SUBJECT: SUSQUEHANNA STEAM ELECTRIC STATION, UNITS 1 AND 2 - ISSUANCE OF AMENDMENTS RE: REVISIONS TO TECHNICAL SPECIFICATION 3.4.10, "RCS PRESSURE AND TEMPERATURE (P/T) LIMITS" (TAC NOS. MF4597 AND MF4598)

SAFETY EVALUATION BY THE OFFICE OF NUCLEAR REACTOR REGULATION
RELATED TO AMENDMENT NO. 263 TO RENEWED FACILITY OPERATING
LICENSE NO. NPF-14 AND AMENDMENT NO. 244
TO RENEWED FACILITY OPERATING LICENSE NO. NPF-22
SUSQUEHANNA NUCLEAR, LLC
ALLEGHENY ELECTRIC COOPERATIVE, INC.
SUSQUEHANNA STEAM ELECTRIC STATION, UNITS 1 AND 2
DOCKET NOS. 50-387 AND 50-388

The amendments change SSES-1 and 2 TS 3.4.10, "RCS [Reactor Coolant System] Pressure and Temperature (P/T) Limits," specifically revising the P/T Limits curves. The revision provides P/T Limits curves that extend into the vacuum region (e.g., below 0 pounds per square inch gauge (psig)) to mitigate the risk of a level transient during startup, account for updated surveillance material and fluence data for the reactor vessel (RV) beltline materials, and replace the current 35.7 and 30.2 effective full power year (EFPY) P/T Limits curves for SSES-1 and 2, respectively, with new curves that are valid for 40 EFPY. The updated analysis

FIGURE 3.4.10-1
 System Hydrotest Limit with Fuel in Vessel for 40 EFY
 (Curve A)

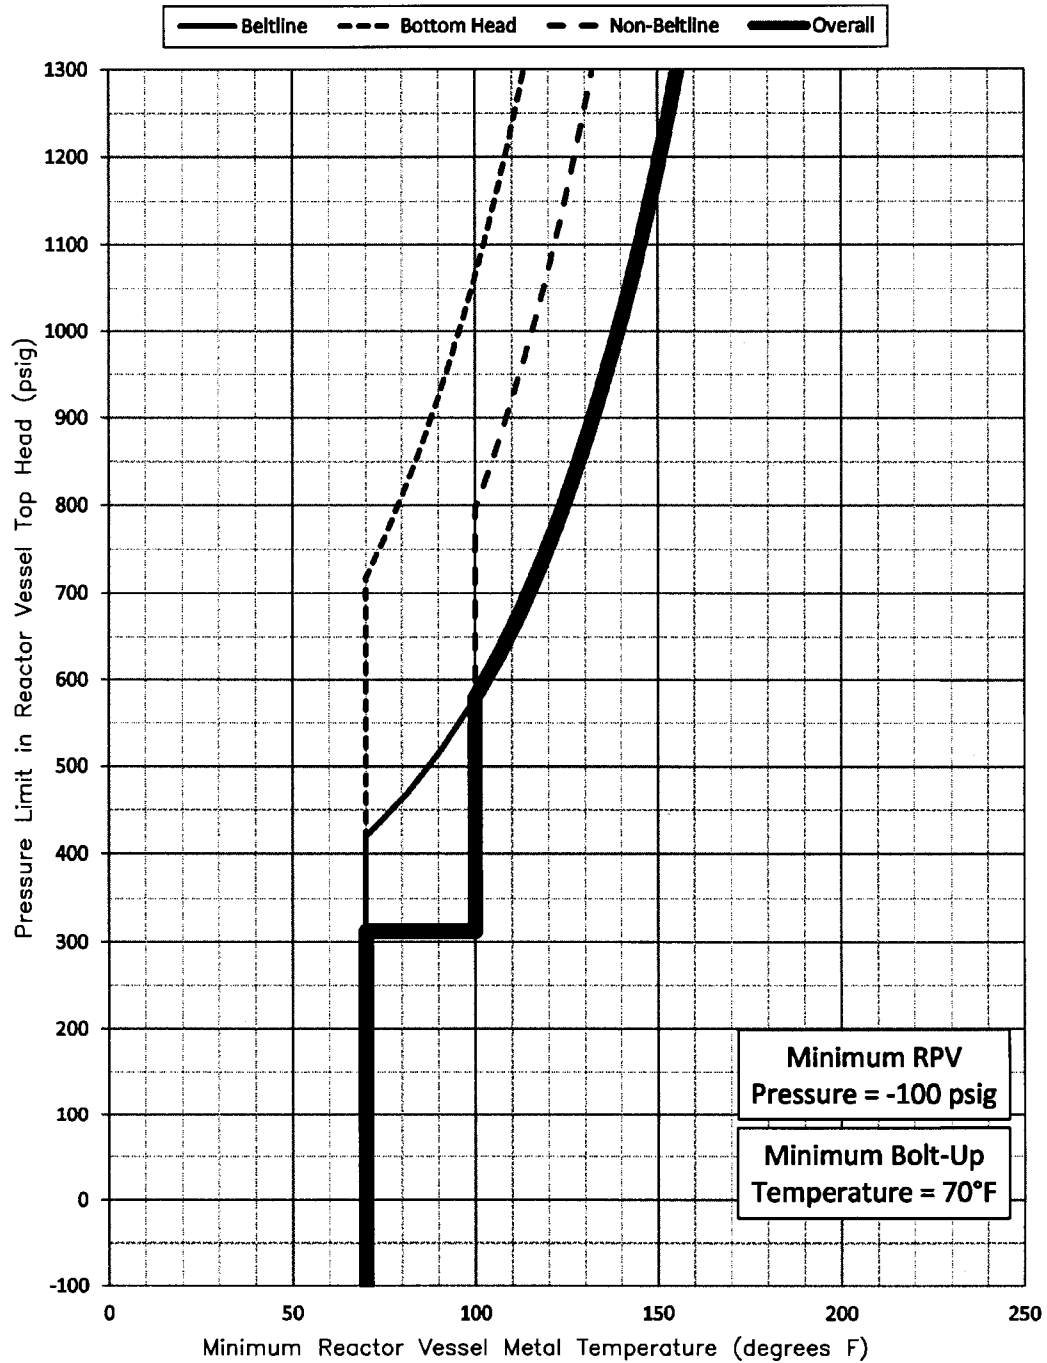
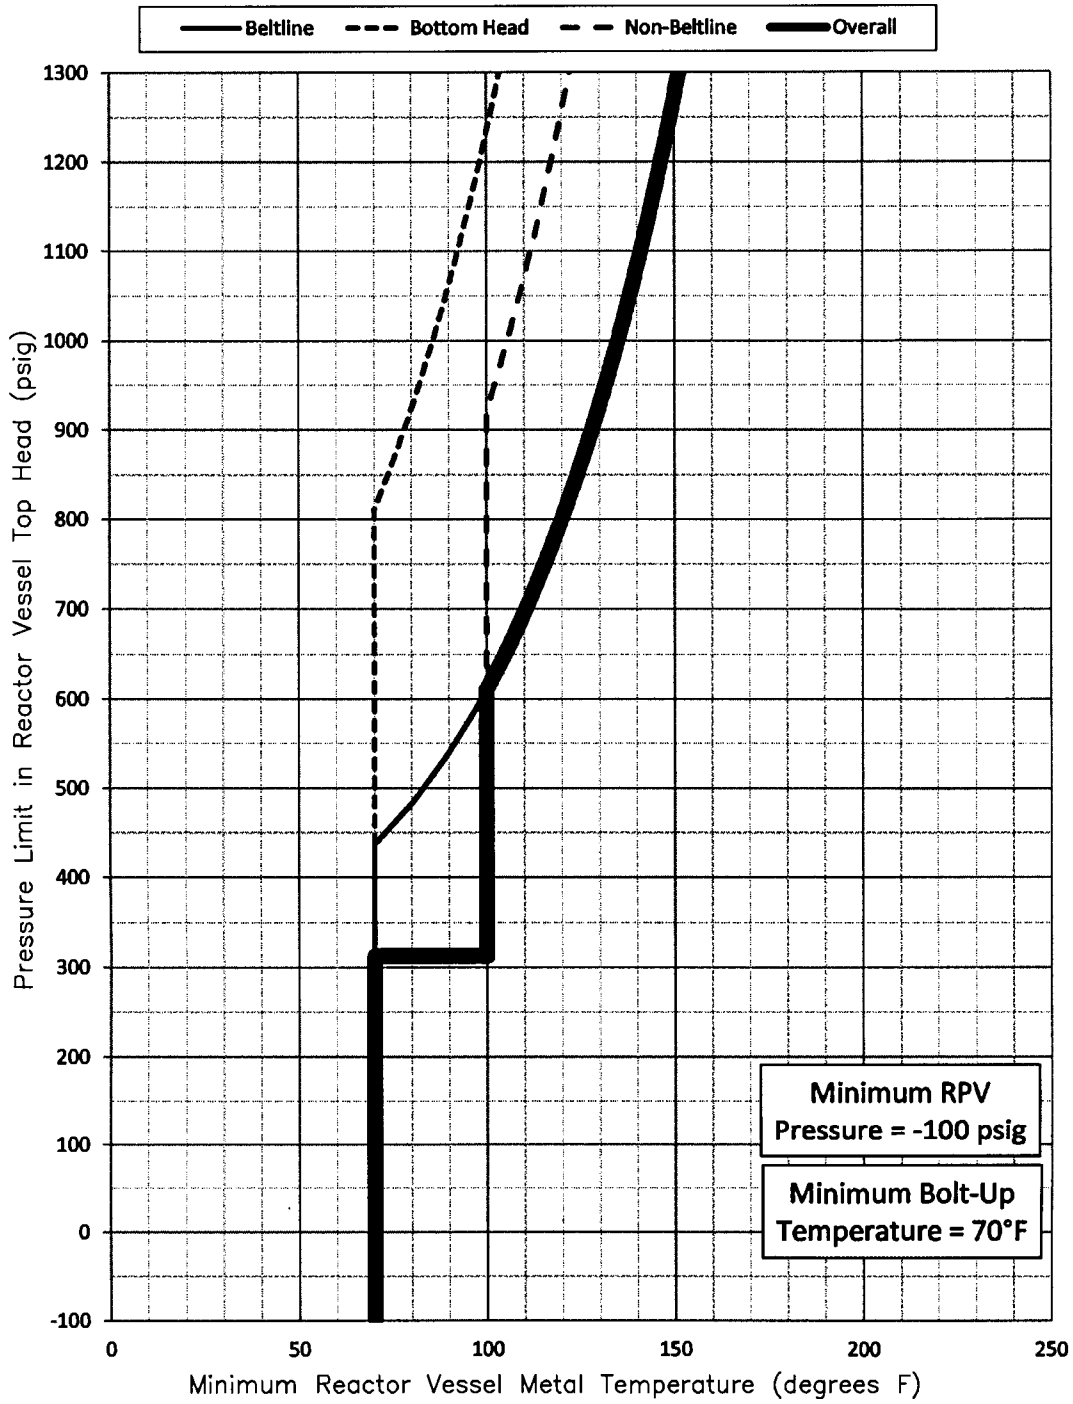
In Reference 1, the licensee proposes the following changes to the TS Figures 3.4.10-1, 3.4.10-2, and 3.4.10-3, which show the P/T Limits curves for in-service leakage and hydrostatic

- The pressure axes are revised to extend below 0 psig to bound RCS conditions to support vacuum-assist fill of the RCS loops.

The pressure axes are extended one additional scaled unit of measure (100 psig each) below 0 psig to bound RCS conditions to support vacuum-assist fill of the RCS loops. Section 4.0 of the LAR states, in part: "The absolute maximum vacuum is assumed to be no greater than 15 psig. This assumes the possibility of drawing a near perfect vacuum on the vessel, coupled with a 0.5 psig containment pressure."

In Reference 2, the licensee further updated the P/T Limits curves based on an updated analysis that addresses considerations included in RIS 2014-11. The new curves account for updated surveillance material and fluence data for the RV beltline materials and would replace the current 35.7 and 30.2 EFPY P/T Limits curves for SSES-1 and 2, respectively, with new curves that are valid for 40 EFPY.

Reference 1 proposed changes to the TS Figures 3.4.10-1, 3.4.10-2, and 3.4.10-3 for the P/T Limits curves for SSE-1 and 2, extending the pressure below 0 psig. The revisions clarify that pressure limits are considered to be met for pressures that are below 0 psig (i.e., up to and including full vacuum conditions). Certain operating practices, such as vacuum fill operations for the RCS, are common practice in both boiling water reactors and pressurized-water reactors and can result in system pressures below 0 psig. Although the RV is not specifically evaluated for negative pressures, the magnitude of the negative pressure is limited to one atmosphere and thus is not expected to result in significant stresses. A perfect vacuum on the vessel would be -14.7 psig. Because the P/T Limits curve figures were revised to extend to -100 psig, the NRC staff asked RAI-2 to the licensee to provide a justification for extending the curves beyond -15 psig. In Reference 2, the licensee provided analyses to demonstrate that the RV cylinder, bottom head and top head locations, have adequate structural margin for values of negative pressure in excess of -100 psig, which significantly exceeds the vacuum pulled on the RV. The licensee noted that during vacuum fill conditions, the maximum drywell pressure of approximately 2 psig should be considered as well for a total of -16.7 psig. While this is the practical limit, the NRC staff concluded that the calculations demonstrated that the RV cylinder, bottom head and top head locations, have structural margin for values in excess of -100 psig. In its response to RAI-2, the licensee stated, in part:

Based on its review of the licensee's submittals, the NRC staff approves the extension of the P/T Limits curves by an additional unit of scale on the pressure axis. The NRC staff determined that although there is a practical restriction to the absolute maximum vacuum of approximately -16.7 psig, adequate structural margin for values of negative pressure in excess of -100 psig exists. Therefore, the NRC staff finds the revisions to SSES-1 and 2 TSs addressing pressures below 0 psig by one unit of scale to be acceptable. This resolves RAI-2.

concludes that the proposed 40 EFPY P/T Limits curves, submitted by Reference 2, are acceptable for incorporation into SSES-1 and 2 TSs. In addition, the NRC staff concludes that the proposed changes to SSES-1 and 2, TS 3.4.10, "RCS Pressure and Temperature (P/T) Limits," to address vacuum fill operations of the RCS, meet the requirements of 10 CFR Part 50, Appendix G. Therefore, the changes to the TSs are acceptable.
